**JAVELINA UNIT 601 (601H,  
602H, 603H, 501H, 502H)  
[fJMB2222150892]**

**C-144/ Permit Approval  
with Conditions**

**JAVELINA UNIT 601 (601H, 602H, 603H, 501H, 502H) [fJMB2222150892]**  
**Temporary Pit non-low chloride fluids. Approval with Conditions.**

NMOCD has reviewed [4323] CHEVRON USA INC, Application and Form C-144 received on August 9, 2022, for the proposed JAVELINA UNIT 601 (601H, 602H, 603H, 501H, 502H) [fJMB2222150892], Temporary Pit in Unit Letter D, Section 9, Township 24S, Range 31E, Eddy County, New Mexico.

**Appendix D – Design Plan****Javelina Unit 601 Pit****Temporary Pit**

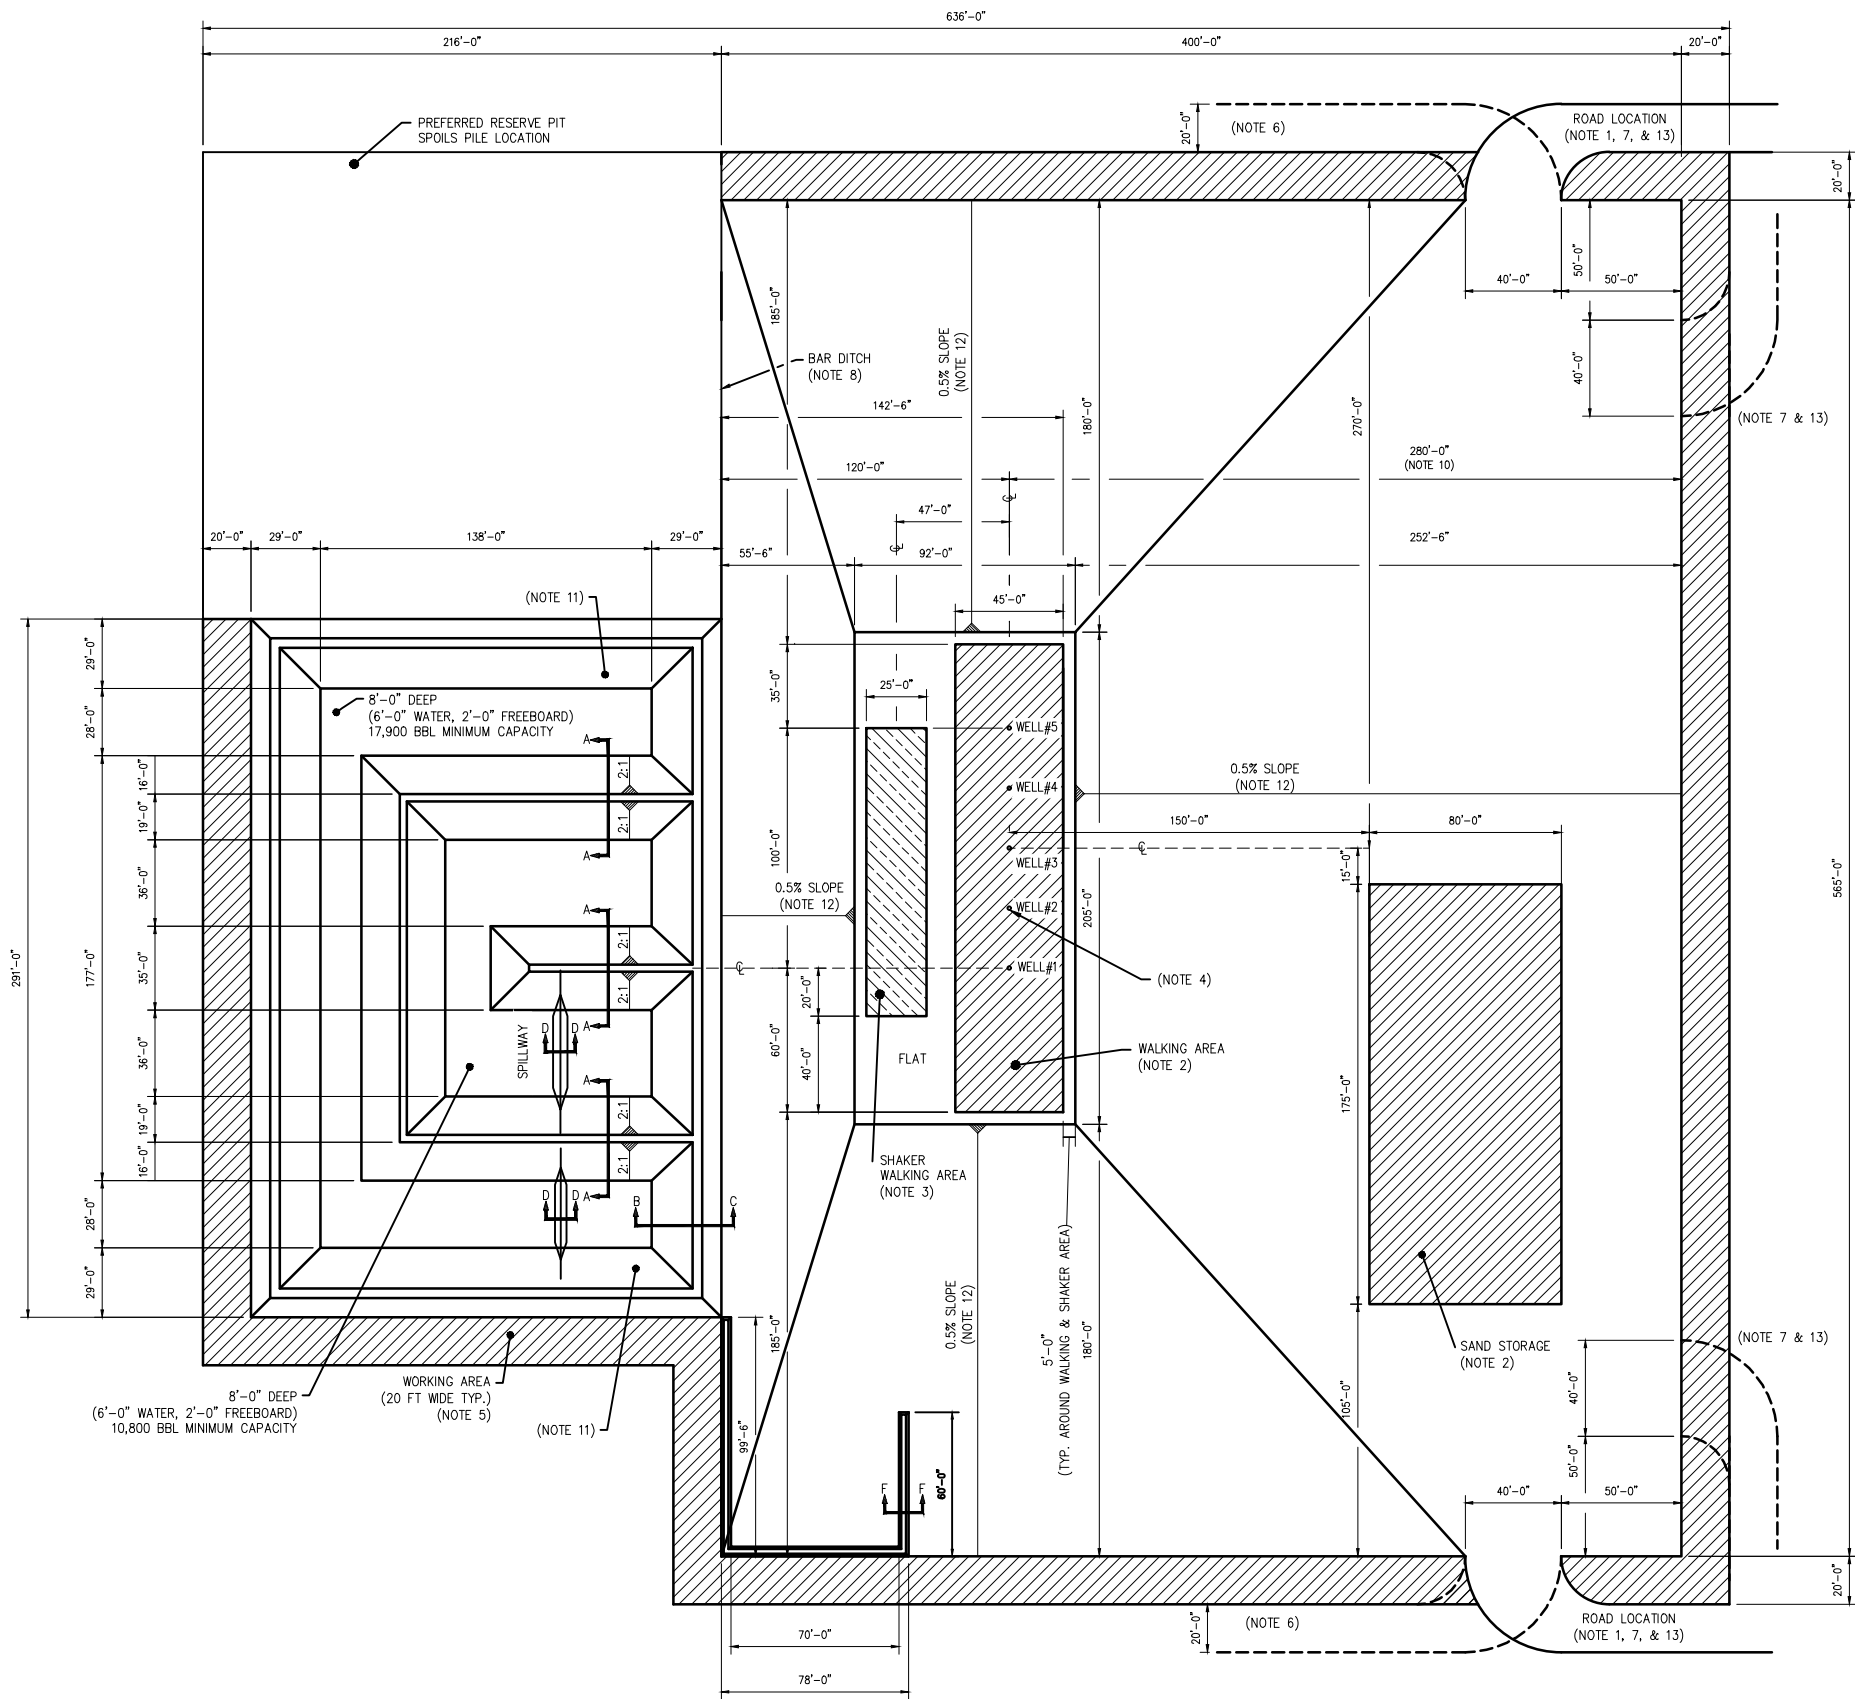
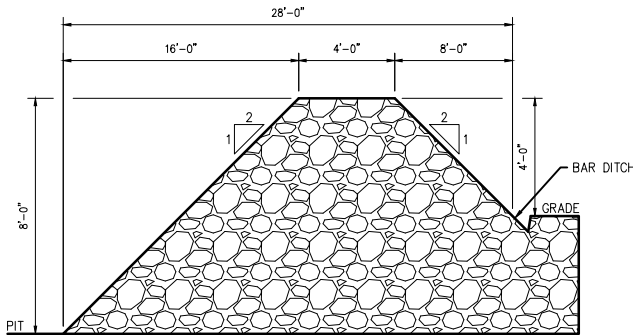
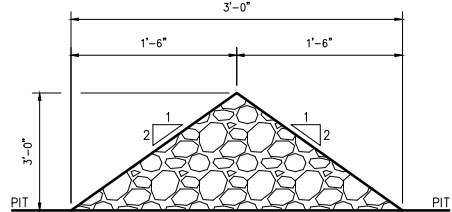
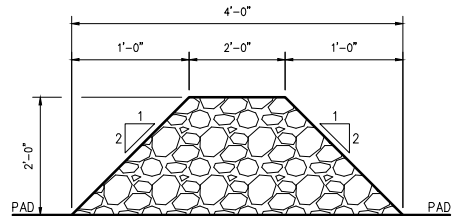
4. The design and construction plan, included as Appendix D of the Application, is approved. [4323] CHEVRON USA INC shall design and construct JAVELINA UNIT 601 (601H, 602H, 603H, 501H, 502H) [fJMB2222150892] Pit as described in the approved plan. [4323] CHEVRON USA INC shall apply for a permit modification for any change to the plan.
